Stressed receiver conformance signal for 100GBASE-SR4

IEEE P802.3bm, September 2014, Ottawa

Example stressed eye: TxVEC19(M=0) ~ 4.7 dB

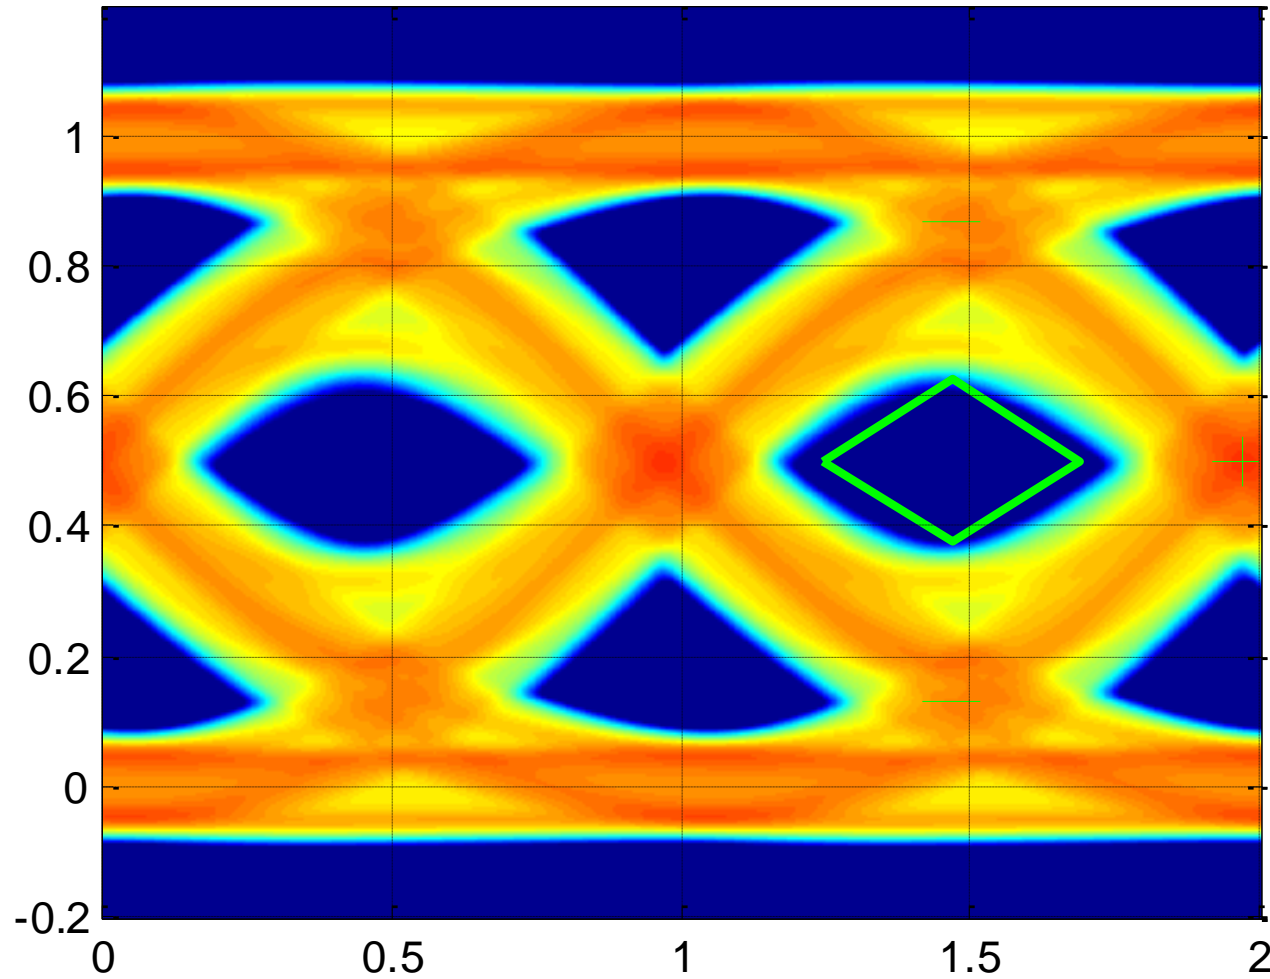
Parameter	Simulated	D3.1 target	Unit	Comment
TxVEC	5.7	≤ 5	dB	Target is too high
TxVEC(M=0)	4.7	No spec	dB	
VECP	6.1	4.2	dB	Target is too high? Measurement affected by scope noise
% from filter	61%	≥ 66.7	%	Target is too high
J2	0.38	0.4	UI	Target is too high
J4	0.51	0.55	UI	Target is too high
Pulse shrinkage	More than half?	No spec		
SJ	0.15	0.05	UI	Target is too low?
J(SI1)	0.1	≤ 0.1	UI	All shrinkage
GJ	0.035	No spec		High bandwidth, "half" shrinkage
Filter 2 type	BT4	No spec	GHz	
BW2	8.7	No spec	GHz	
SI2	0.11	No spec	(pk-pk) / OMA

Example stressed eye: VECP = 4.2 dB

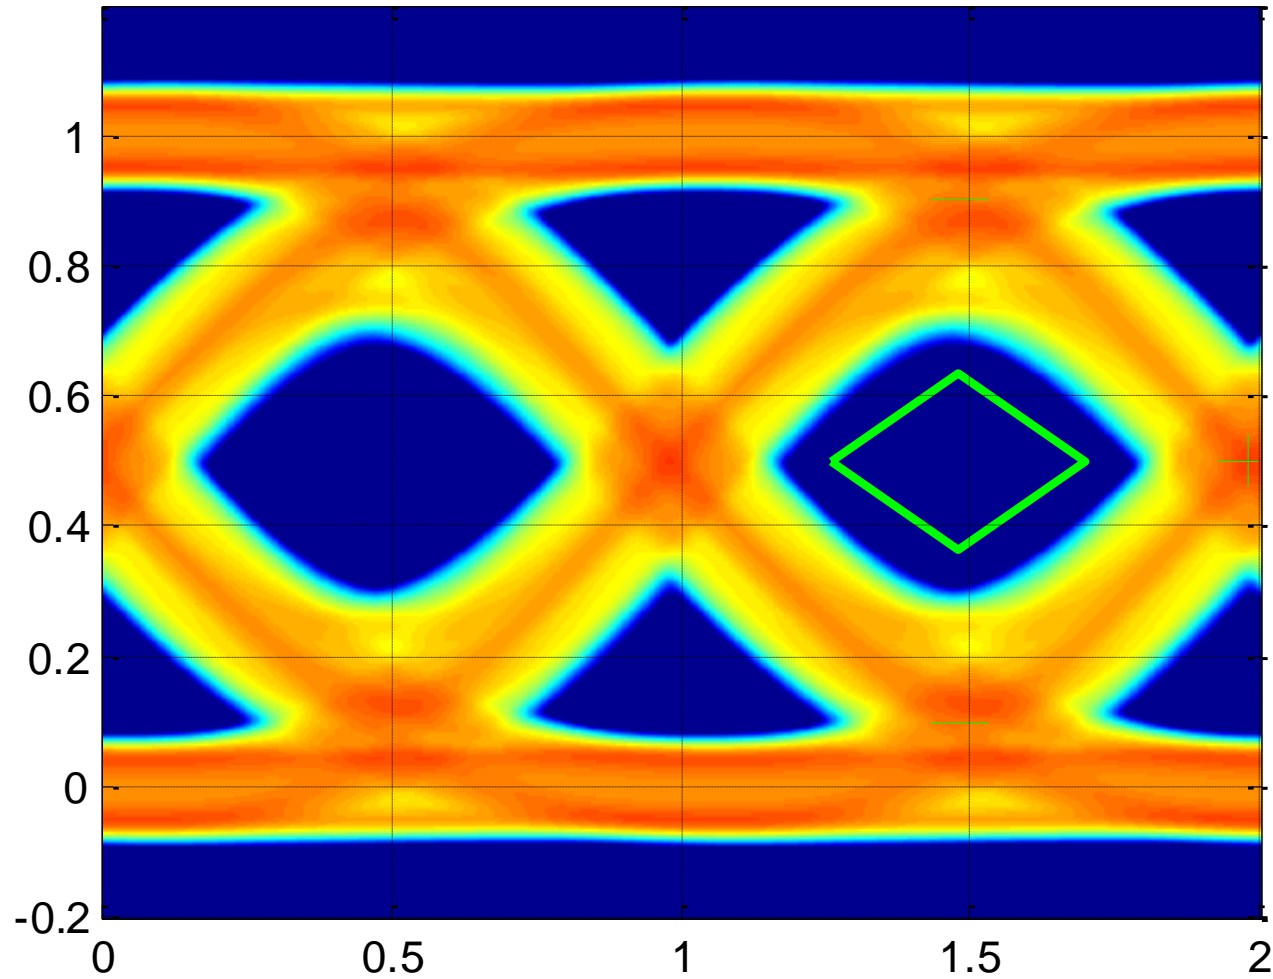
Parameter	Simulated	D3.1 target	Unit	Comment
TxVEC	3.3	≤ 5	dB	Target is too high
TxVEC(M=0)	3.0	No spec	dB	
VECP	4.2	4.2	dB	Target is too high? Measurement affected by scope noise
% from filter	61%	≥ 66.7	%	Target is too high
J2	0.34	0.4	UI	Target is too high
J4	0.45	0.55	UI	Target is too high
Pulse shrinkage	60%	No spec		
SJ	0.15	0.05	UI	Target is too low?
J(SI1)	0.1	≤ 0.1	UI	All shrinkage
GJ	0.035	No spec		High bandwidth, "half" shrinkage
Filter 2 type	BT4	No spec	GHz	
BW2	10.3	No spec	GHz	
SI2	0.11	No spec	(pk-pk) / OMA
